INDESIT company

Model type:
LV620IX

Commercial code:
F029941

n1045069: Modification of racks and dispenser lid on EVO3 dishwashers

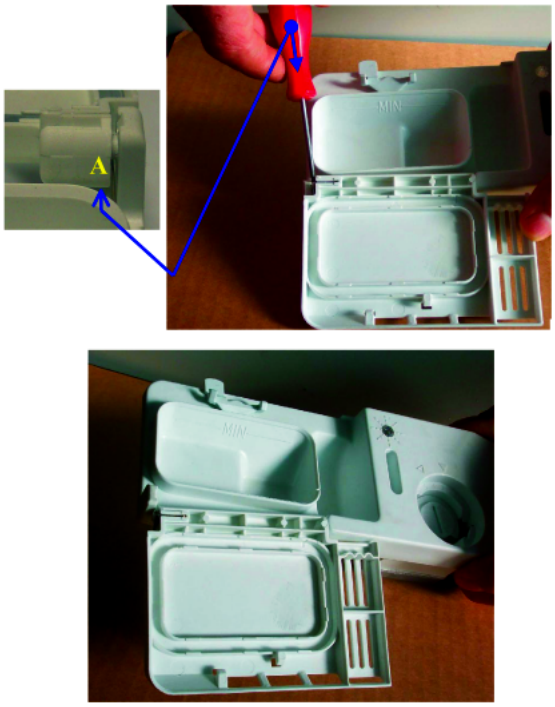
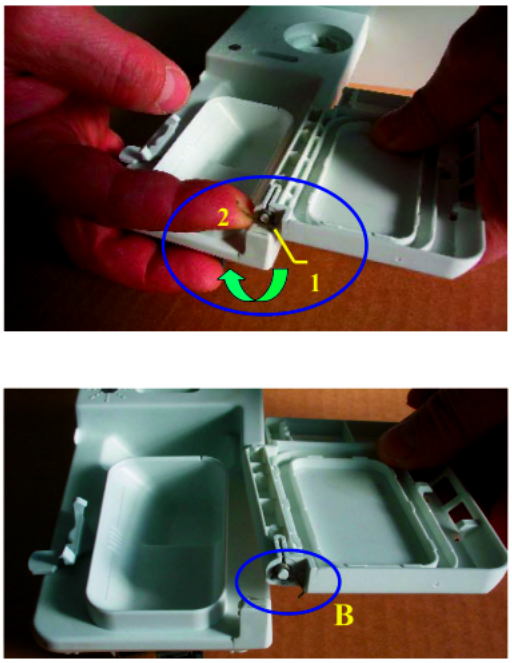
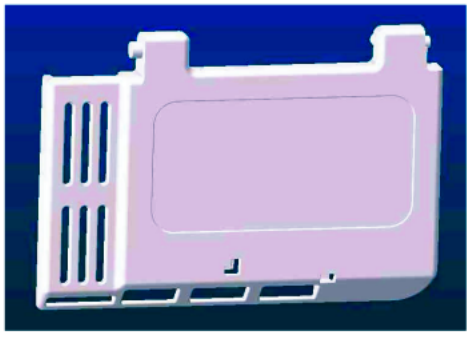
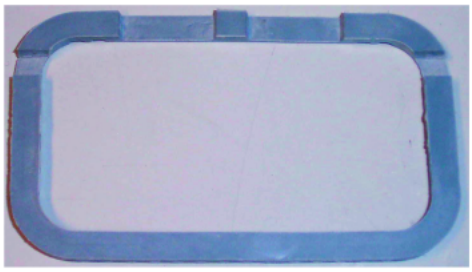
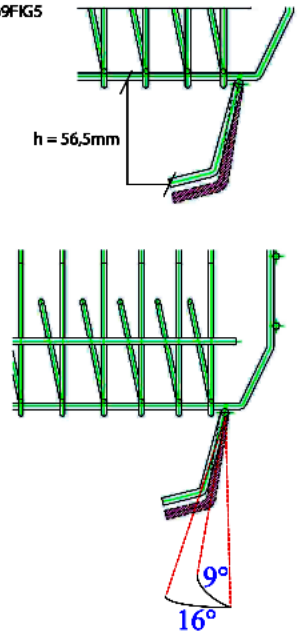
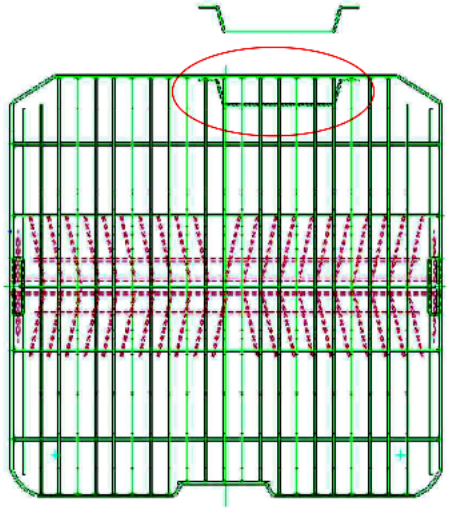
To obtain better dissolving of the detergent during the wash cycle, the following modifications have been made to EVO3 dishwashers:
- new dispenser lid, replacement code 098134 (see figure N1045069FIG4) created;
- upper racks modified with lid catch angle changed from 9° to 16° (see figure N1045069FIG5);
- MultiSystem lower racks modified with insertion of a spacer wire at the electric dispenser (see figure N1045069FIG6).

Lid installation instructions:
1) prise the lid out of the dispenser seat using a small screwdriver at point A (figure N1045069FIG1);
2) replace the lid, checking that release spring B (figure N1045069FIG2) is in place; before fitting the new lid load the spring from position 1 to position 2 (figure N1045069FIG2);
3) fit the lid in its special seat and check for correct operation (figure N1045069FIG3).
Lid closing may be harder for the first few cycles after replacement, due to settling of the material.

The upper and lower racks have the same spare part codes as the premodification items; Replacements Warehouse stocks have been replaced.

N1045076FIG1

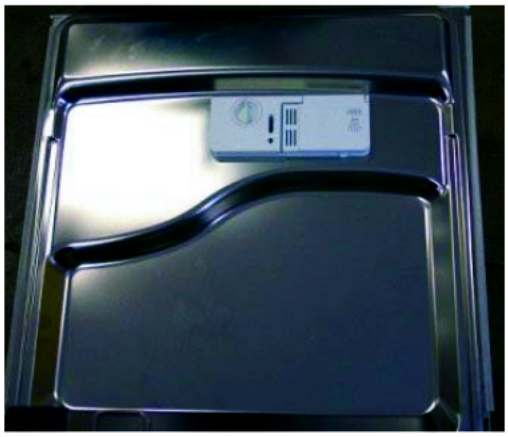
The position of the electric distributor has been changed as shown in the attached illustration.
The new machines have a new industrial code.

Introduced items:
C00108980 upper rack
C00109698 inside door

Premodification items:
C00094235 upper rack
C00095276 inside door

N1045083FIG1

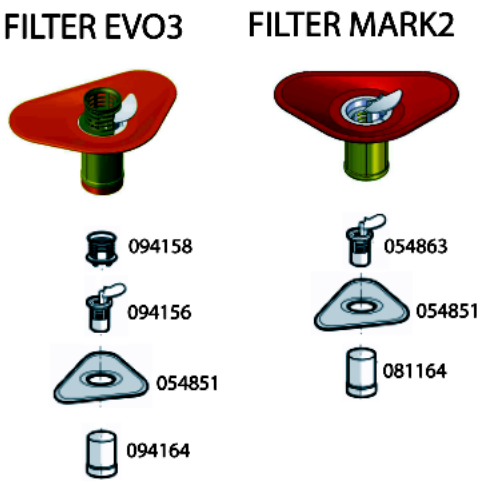
All dishwasher models affected by this modification have been equipped with the items listed below, in order to solve the drain

pump clooging problem.

Introduction of:
Cylindrical plastic filter code 081164
Central filter code 054863

Elimination of:
Cylindrical plastic filter code 094164
Central filter code 094156
Central filter grid code 094158

The modification has been introduced progressively, starting from serial no. 40516.0001.

N1045133/134FIG1

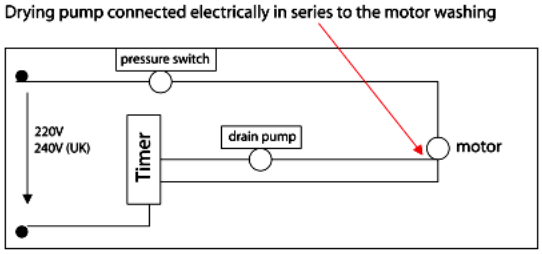
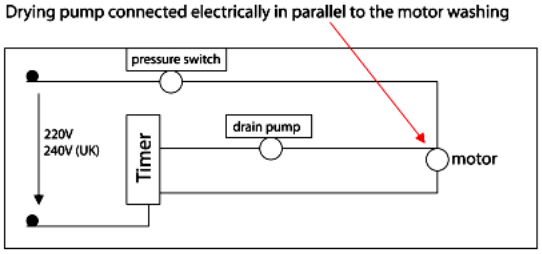
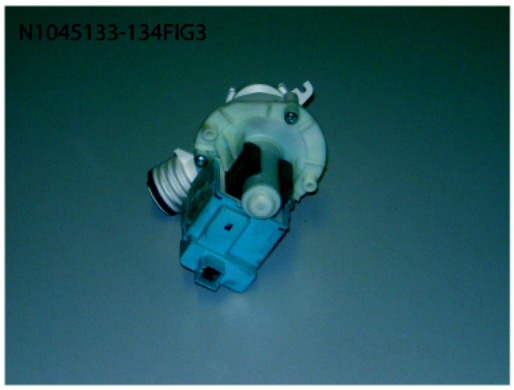
The drain pump electrical connection has been modified from a configuration in series with the wash electric pump to one in parallel.

The drain pump in series with the wash electric pump is fed through the wash electric pump causing a voltage drop equal to -15V (diagram N1045133-134FIG1).

The drain pump in series with the wash electric pump is electrically fed directly by the F-N line, without any voltage drop (diagram N1045133-134FIG1).

New parts:
Wiring in parallel
C00118767(Rohs 143766) - thermoprotected drain pump 220/240V 50HZ 26W - picture (N1045133-134FIG3)

Premodification parts:
Wiring in series
C00112306(Rohs 143739) - drain pump 230V 50HZ 22W - picture (N1045133-134FIG4)

Important!!
The thermoprotected drain pump cannot be installed on premodification dishwashers.
The non-thermoprotected drain pump cannot be installed on modified dishwashers.

N1045136FIG1

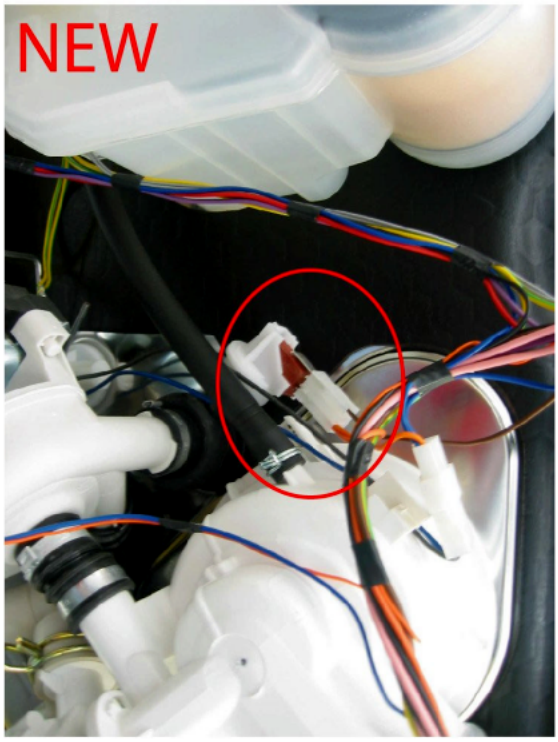
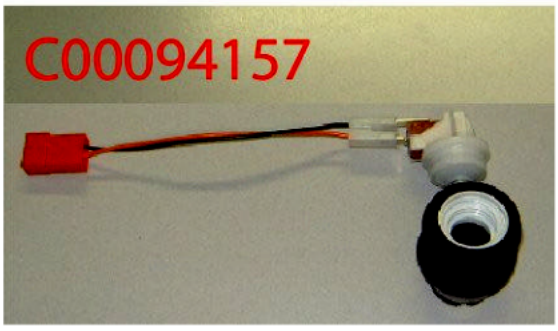
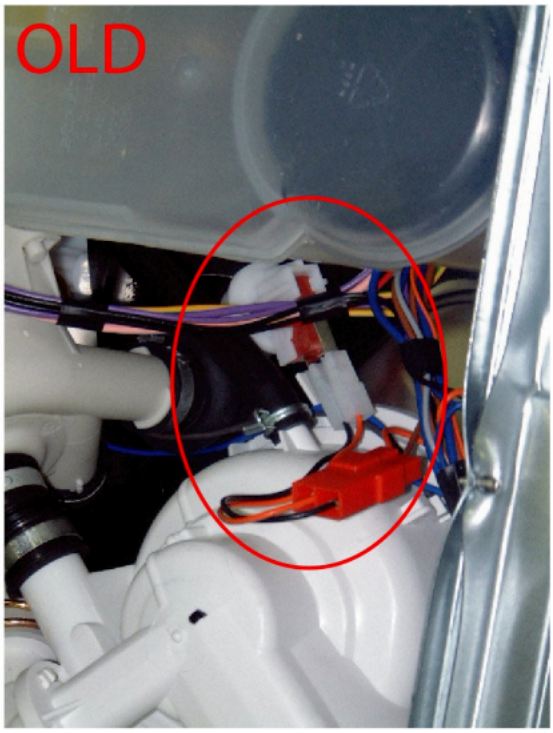
In modified products the connector going to the high pressure sensor is part of the wiring assembly (see picture N1045136FIG1). In premodification products the high pressure sensor is connected to the wiring assembly by a cable that is part of code C00094157 (see pictures N1045136FIG2-3).

New parts
Wiring
C00142435 - high pressure sensor

Premodification parts
Wiring
C00094157 - high pressure sensor + cable

The new parts are not individually interchangeable with premodification ones.
